*Appendix C*

**Agency Correspondence**

SUBJECT: Floodplain Service Number: 09-41-0028-FP  
T 07N, R 11W, City of Grand Rapids, Kent County, Grand River

Enclosure

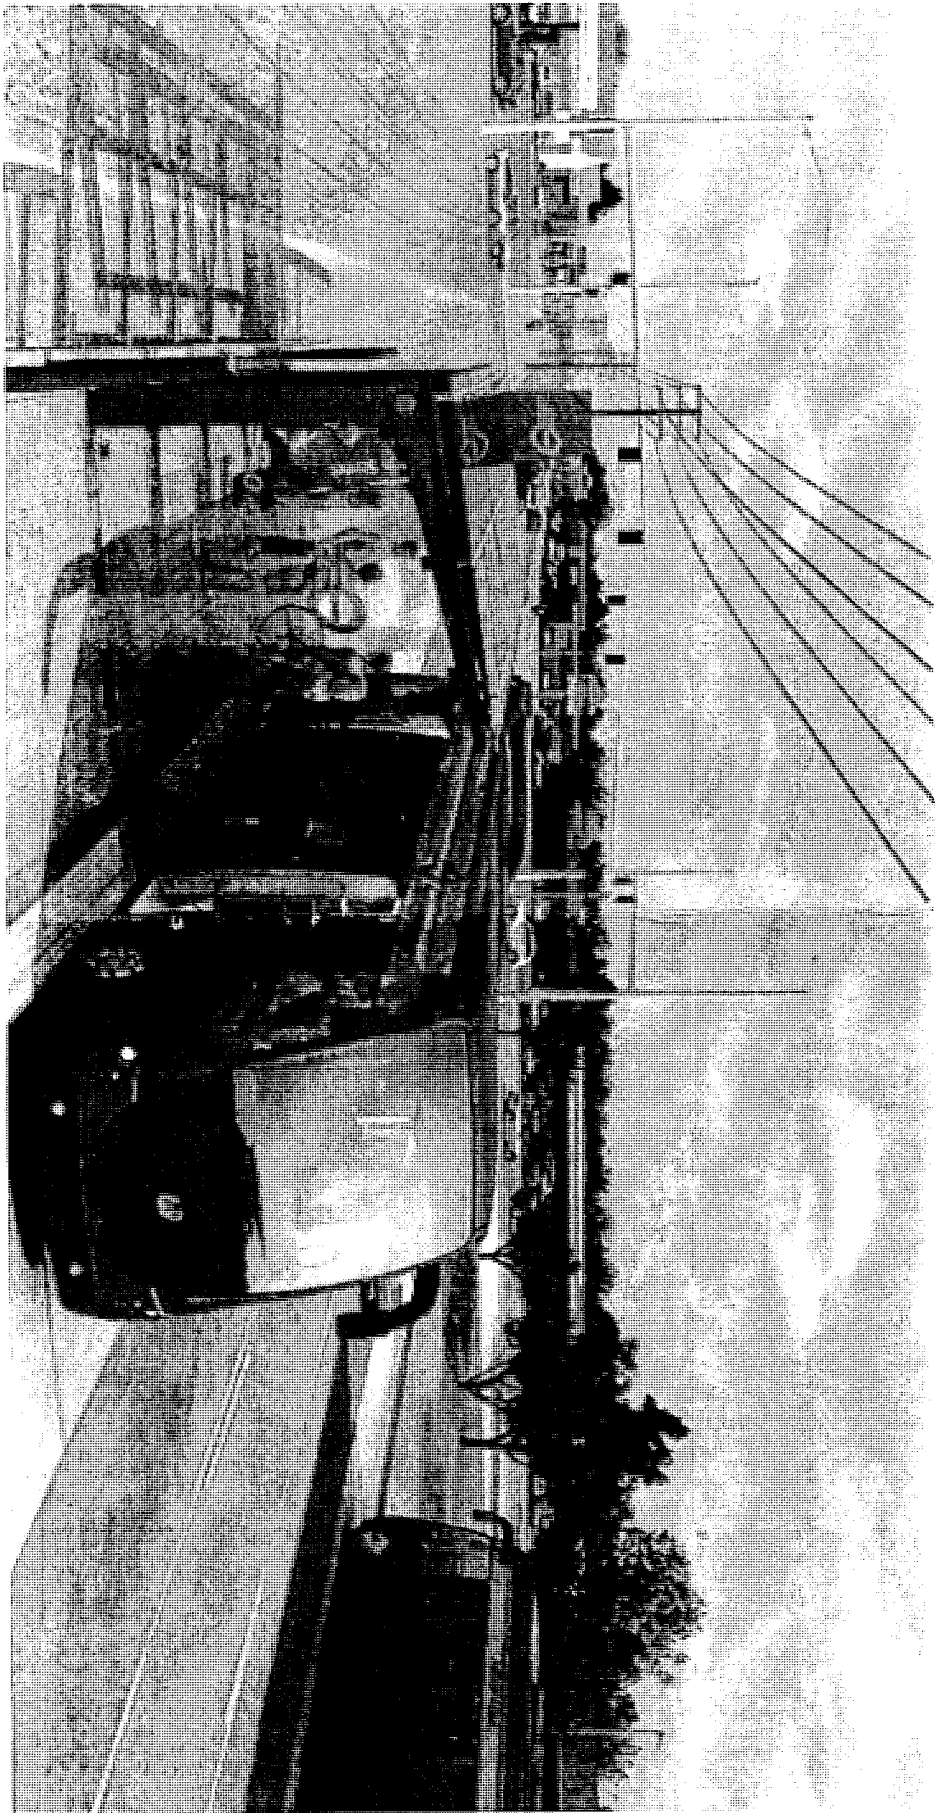
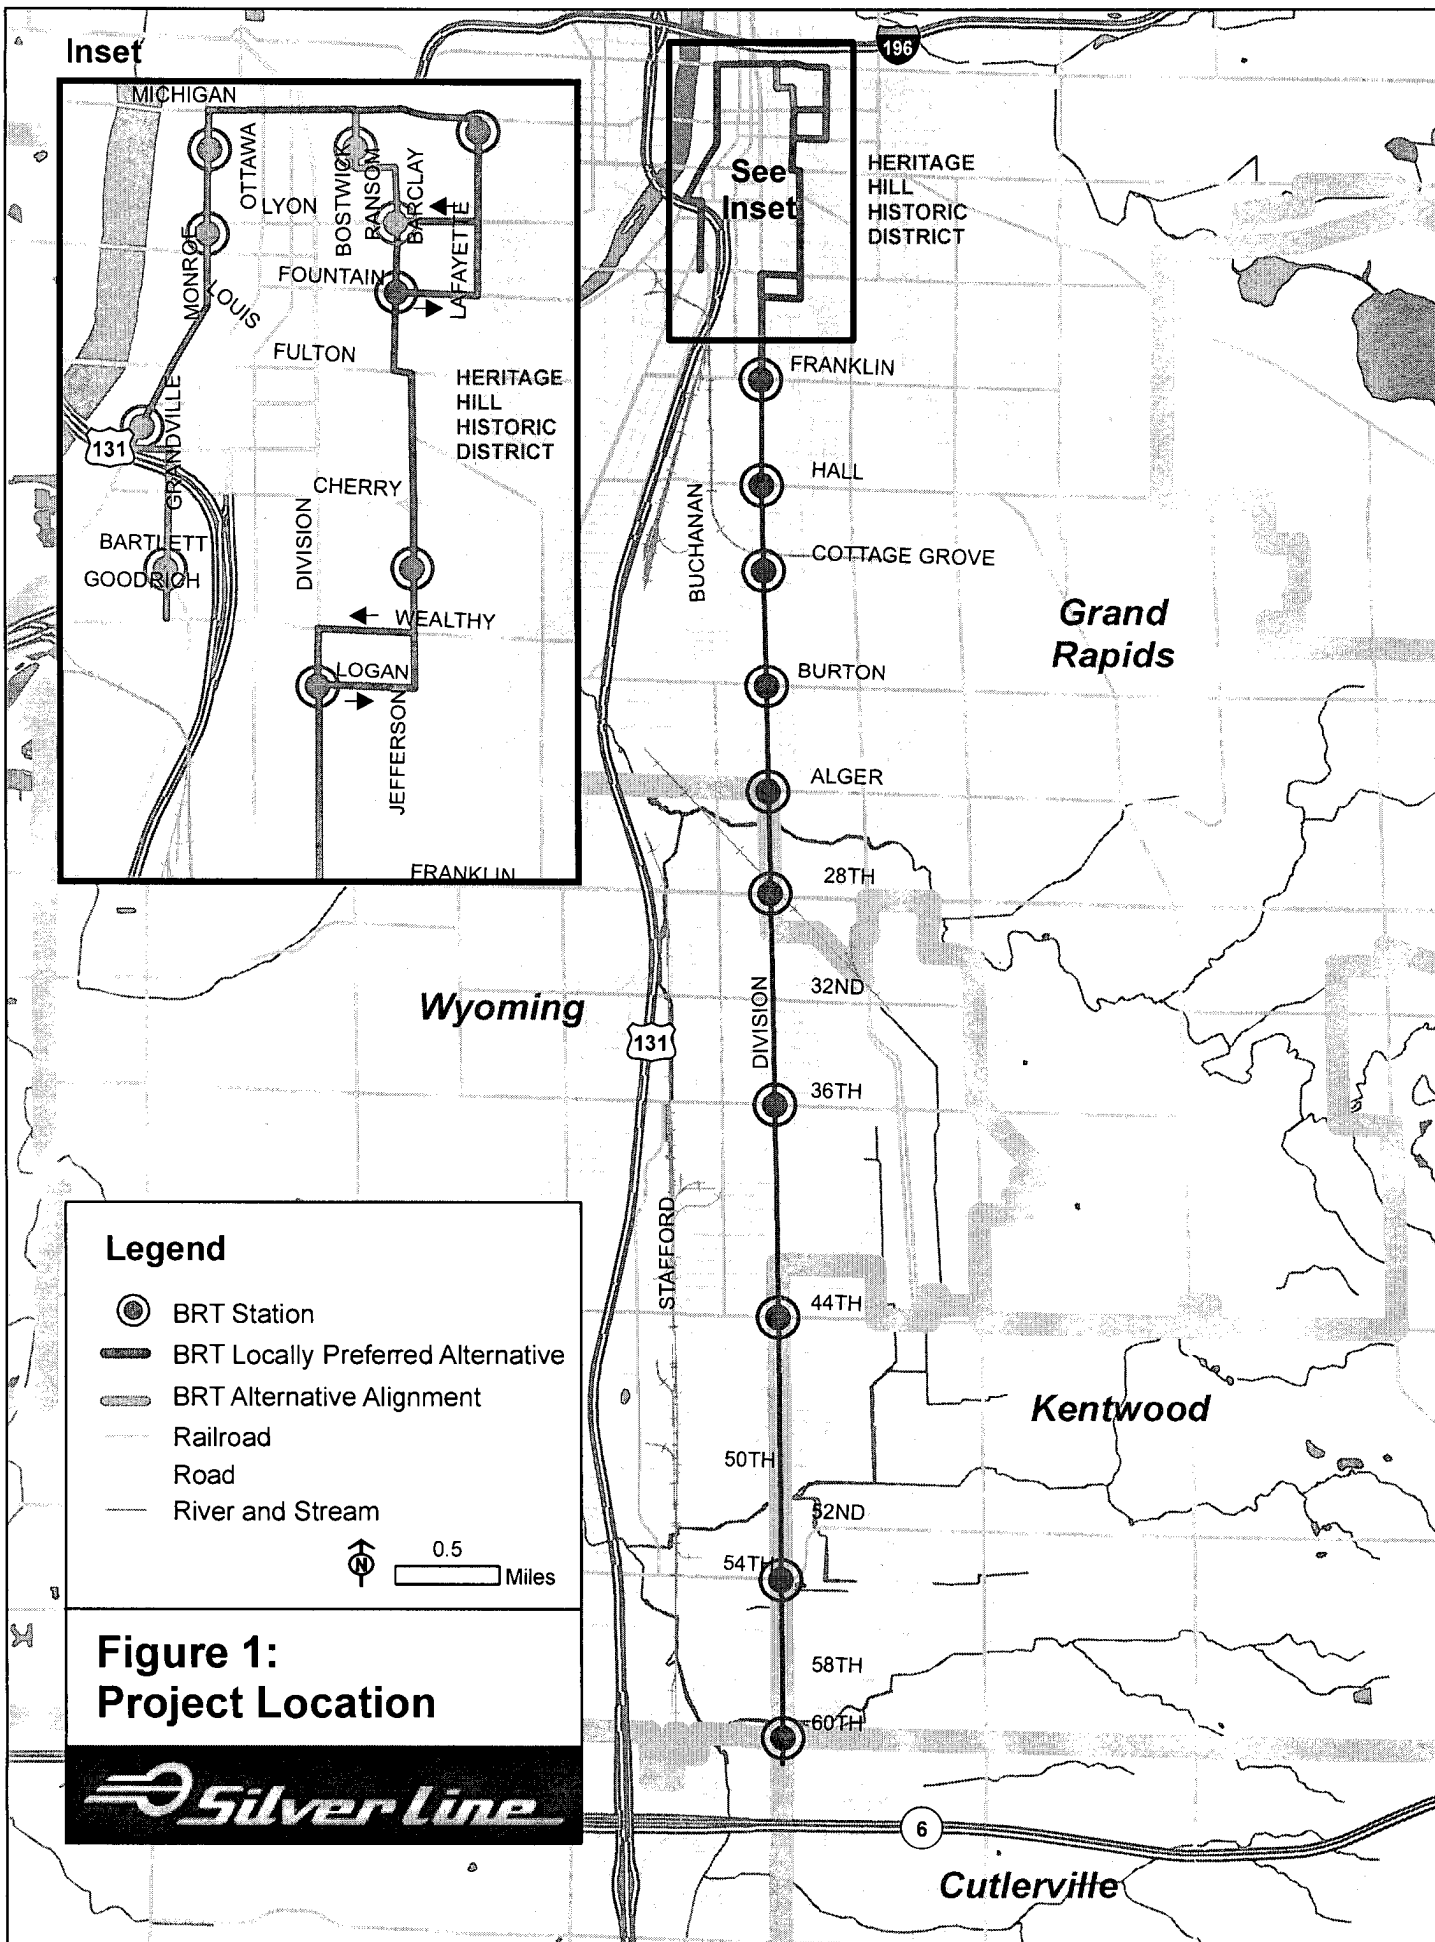
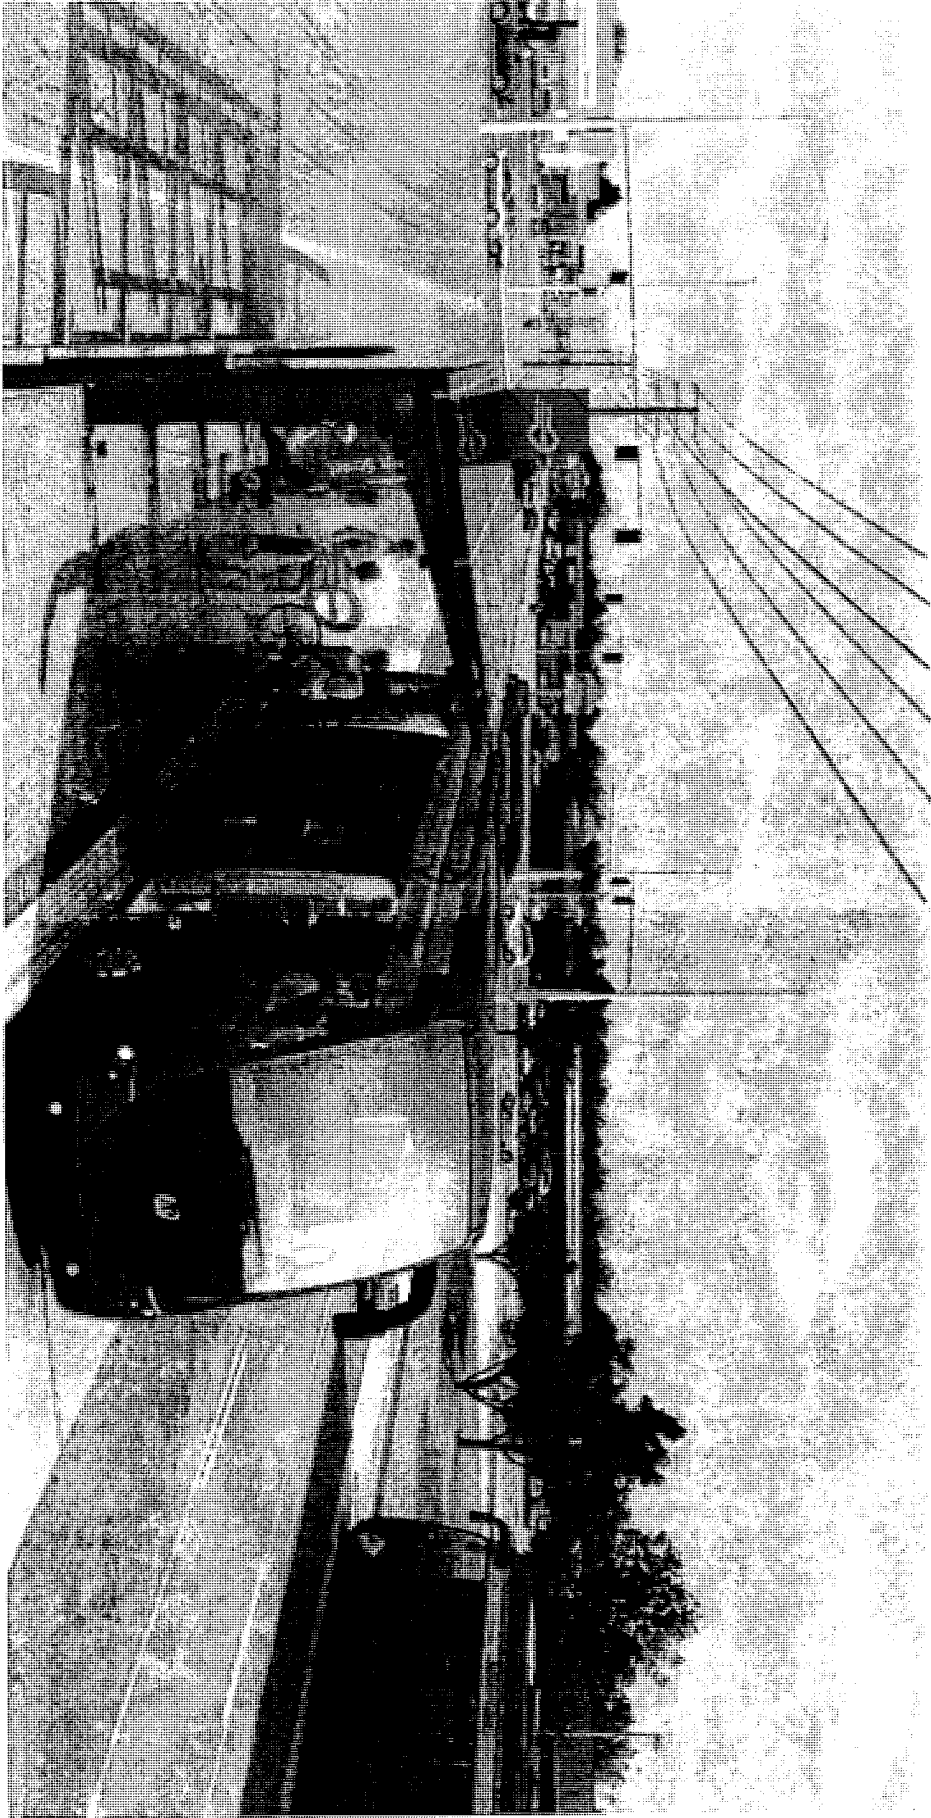
Your proposed project is to install bus stop benches, partially enclosed (but not fully enclosed), according to the attached design and locations. Based on this information, no permit will be required under the State's Floodplain Regulatory Authority found in Part 31, Water Resources Protection, of the Natural Resources and Environmental Protection Act, 1994 PA 451, as amended (Part 31) for the installation of these bus stops. A permit may be required, however, for any additional work such as filling or grading in regulated areas.
